**RECORD OF DECISION  
KENILWORTH PARK LANDFILL  
NATIONAL CAPITAL PARKS—EAST  
NATIONAL PARK SERVICE  
WASHINGTON, D.C.**

**July 2022**

## FIGURE 1: CONCENTRATION DISTRIBUTION OF TOTAL PCBS (KPS)

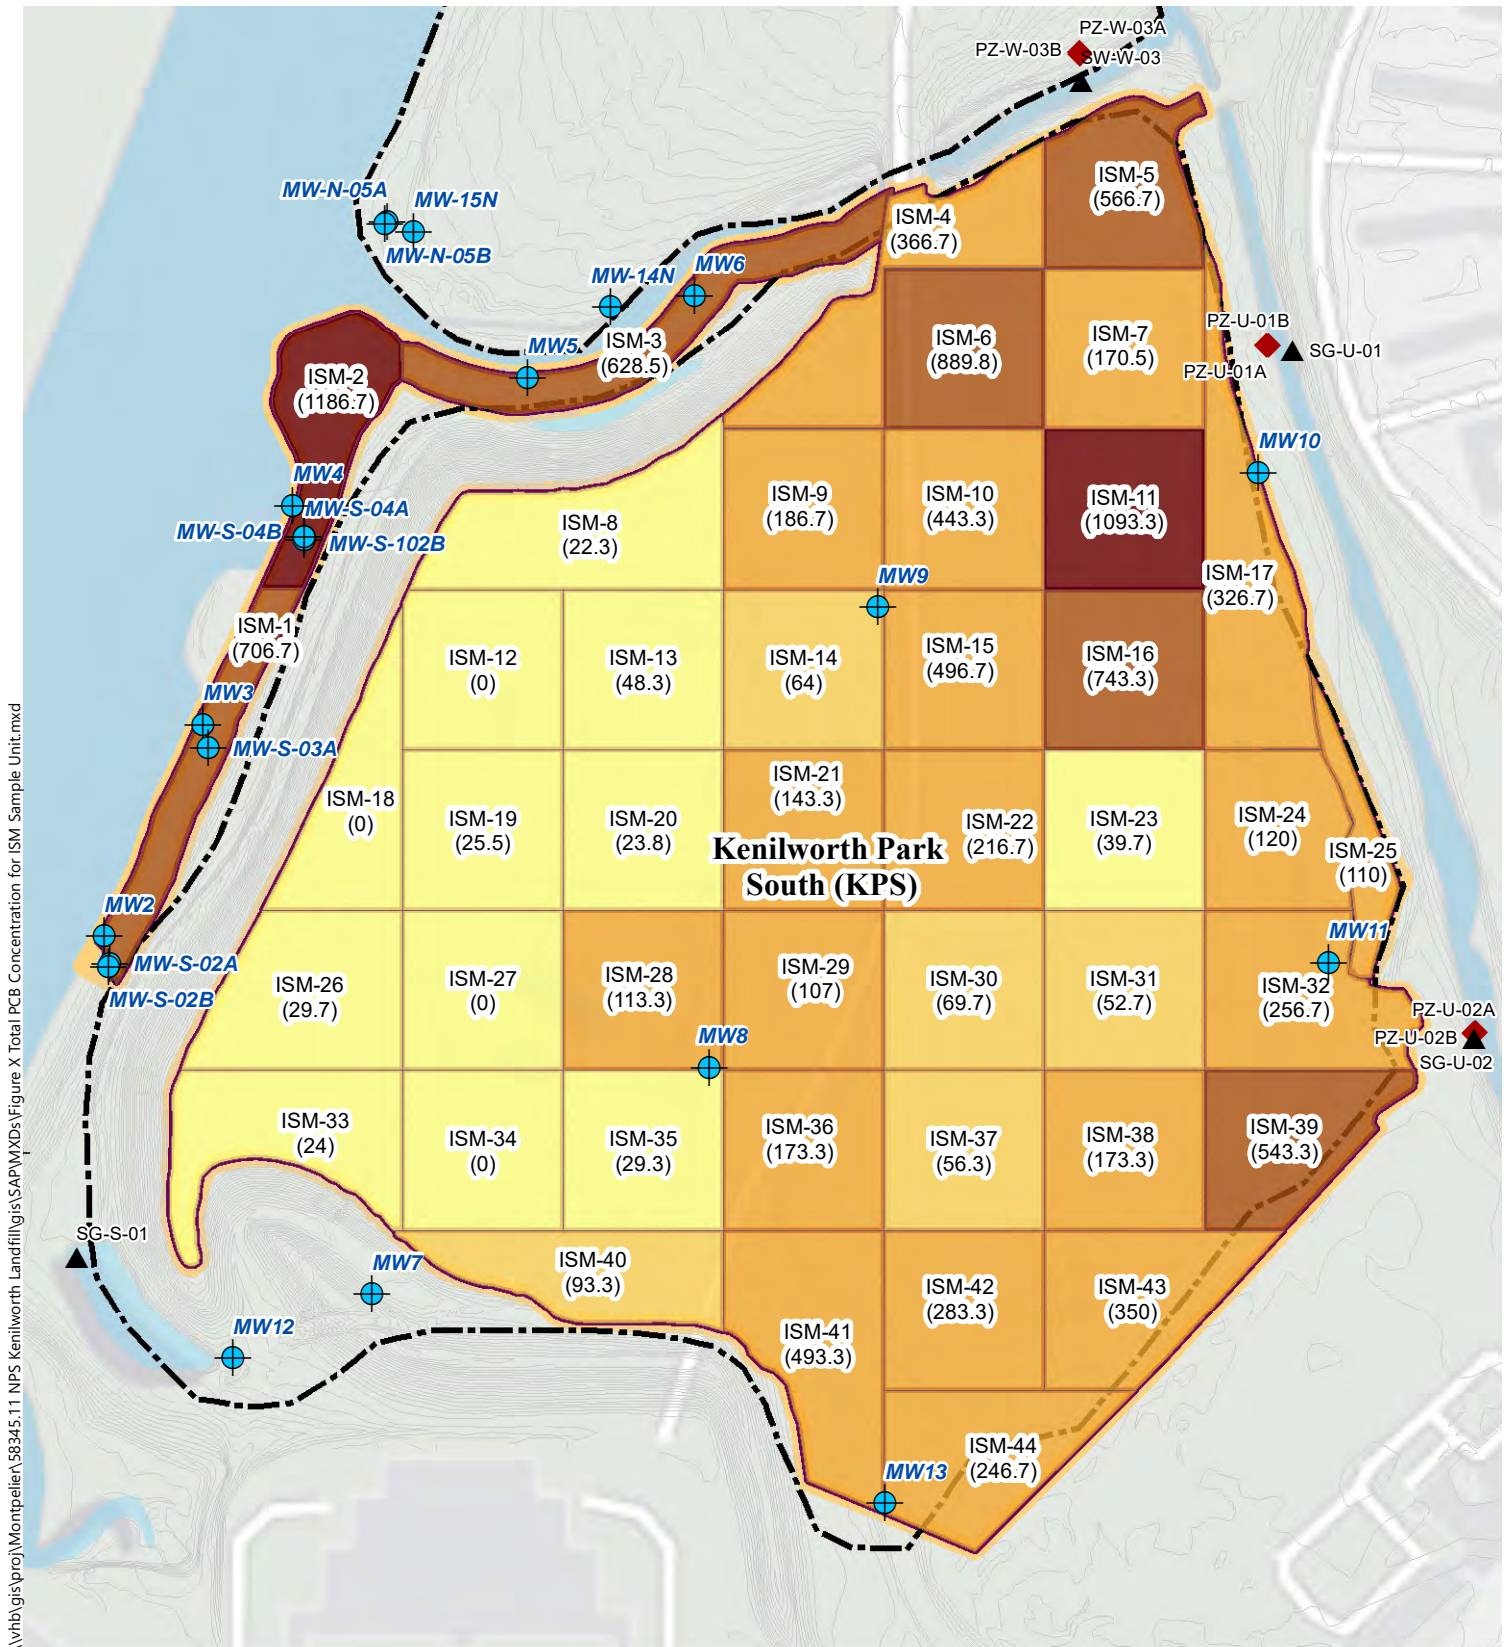
- As shown on Figure 1, three of the KPS SUs where total PCB Aroclor concentrations were elevated relative to the other SUs (ISM-1, ISM-2, and ISM-3) are within the floodplain of the Anacostia River and Watts Branch. The concentrations of PCB Aroclors in the nearest ISM SUs upgradient of that floodplain area (ISM-8, ISM-12, ISM-18, and ISM-26) were significantly lower. Sediment deposition during flooding is a widely

Figure 1: Proposed Adjustments to Alternative 3 to Support Future Uses

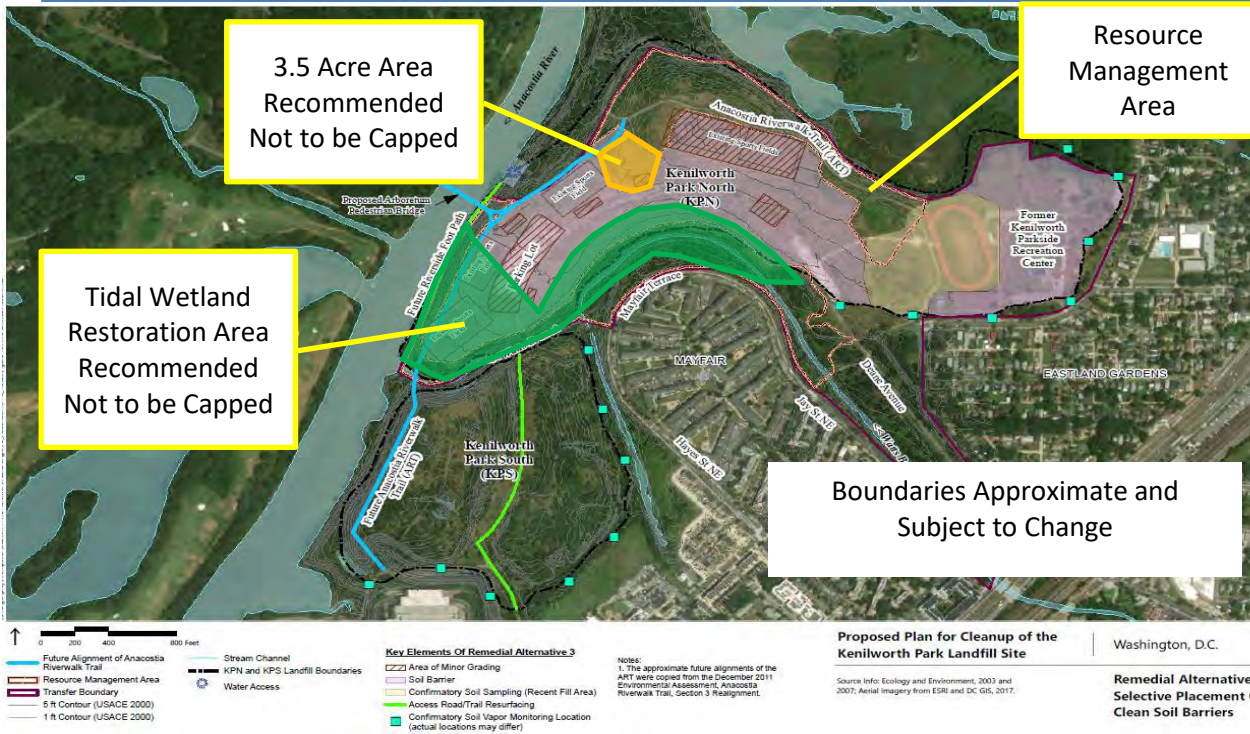
To reduce flood risk associated with sea level rise and more intense storm events, as well as increase the acreage of wetlands in the District, DOEE recommends not capping 21 acres along Watts Branch and the Anacostia River (shown in green on Figure 1). After KPN is transferred to the District and the remedy is implemented and separate from the CERCLA process, DOEE intends to restore tidal wetlands to this area. As part of the remedy, DOEE therefore recommends implementing institutional controls that would limit area access and prohibit organized sports, recreation, special events, and construction of higher intensity visitor use features in order to address human health risk prior to any wetland restoration efforts. Institutional controls could be a combination of existing natural barriers, newly installed natural

Limited meadow habitat exists in the District. To reduce impacts on SGCNs and minimize net loss of habitat at KPN, DOEE recommends not capping approximately 3.5 acres of meadow habitat in KPN (shown in orange on Figure 1), and instead implementing institutional controls to limit access in order to conserve critical meadow habitat for SGCNs. This area was selected because its location adjacent to similar habitat in the Resource Management Area (boundary shown on Figure 1) would provide an area of unfragmented, critical habitat that would support the territory needs of SGCNs. It could take more than 10 years after a cap is installed for native vegetation to become re-established and again provide high-value habitat, leading to loss of some SGCN species and population reductions in other SGCNs currently found at the site. The uncapped meadow area could still be utilized for passive recreation. Institutional controls discussed in the following section would address human health risk by prohibiting more active recreation from occurring in the uncapped meadow. The boundaries of the uncapped area could potentially be adjusted based on further PCB sampling as well as consideration of additional wildlife monitoring and community input during the planning process for the site. DOEE also recommends additional safeguards to minimize impacts to SGCNs in the meadow areas that will be capped, including relocating SGCNs to the uncapped areas of the Site, timing the implementation of the selected remedy to account for SGCN behavior, and developing a planting plan to introduce native plants.

NPS’s Selected Remedy (Figure 2) includes modifications based on the preliminary land use plans DOEE submitted to NPS, which include wetland restoration along Watts Branch and the Anacostia River and an area reserved for meadow habitat on KPN (Attachment 24). During the remedial design phase, additional modifications can be made to the clean soil barrier to accommodate the District’s final plans for KPN. The clean soil barrier is required only in high-frequency, high-intensity land use areas such as athletic fields. If the District reserves additional areas of KPN for open space, or habitat restoration (i.e., not developed as athletic fields or public gathering areas), no clean soil barrier will be required in those areas.
